SOURCE CONTROL DRAWING (25)

PART NO. 12422745

PWIC A	UNLESS OTHERWISE SPECIFIED DIMENSIONS ARE IN MILLIMETERS TOLERANCES ON 1 PLACE ± — 2 PLACE ± —	CONTRACT NUMBER DAAE07-98-C-M005 CONTRACTOR STEWART & STEVENSON SERVICES SEALY TEXAS U.S.A.	DESIGN ACTIVITY U.S. ARMY TANK AUTOMOTIVE COMMAND WARREN, MICHIGAN 48397-5000
	THIRD ANGLE PROJECTION	DRAWN BY C.AXMACHER / DATE (YR-MO-DA) 01/07/26	AXLE ASSEMBLY, FRONT, DRIVE, STEERING, ABS
		CHECKER T.FON / ENGINEER T.FON	
NEXT ASSY / USED ON	QA P.FIESTER	DRAWING APPROVAL - GOV'T R.REDDY	SIZE E / CAGE CODE 19207 / DWG NO 12422745
APPLICATION	MAT'L ENGR M.CHURCH	DESIGN APPROVAL - GOV'T R.REDDY	SCALE 1/4 / UNIT WT — / SHEET 2 OF 3

SECTION **A-A**
SH 3, C6
SHOWN WITHOUT 1°42′
AXLE INSTALLATION ANGLE
(PINION STEM UP)

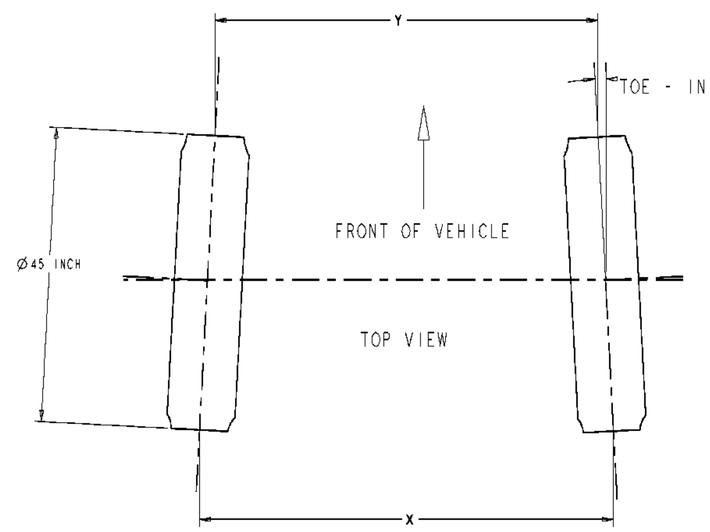
REVISIONS				
ZONE	REV	DESCRIPTION	DATE	APPROVED
—	—	ALL REVISIONS LISTED ON SH 1	—	—
—	-	INITIAL RELEASE -PRODUCT BASELINE- ERR SSS-R6714	—	—
C4 A4 C4	B	3) ADDED FLAG NOTE 29 CALLOUT 4) REPLACED DISTRIBUTION STATENENT A 5) DIM 1.59mm WAS 4.75m DIM 1/16" WAS 3/16" ERR SSS-U7374	03-01-27	B.PUSTKA HJH BP

TOTAL TOE-IN = X - Y
(29) TOTAL TOE-IN = 1.59mm ±2.36mm @ 571.5mm
(1/16" ±3/32") @ (22 1/2") FROM ℄ OF AXLE
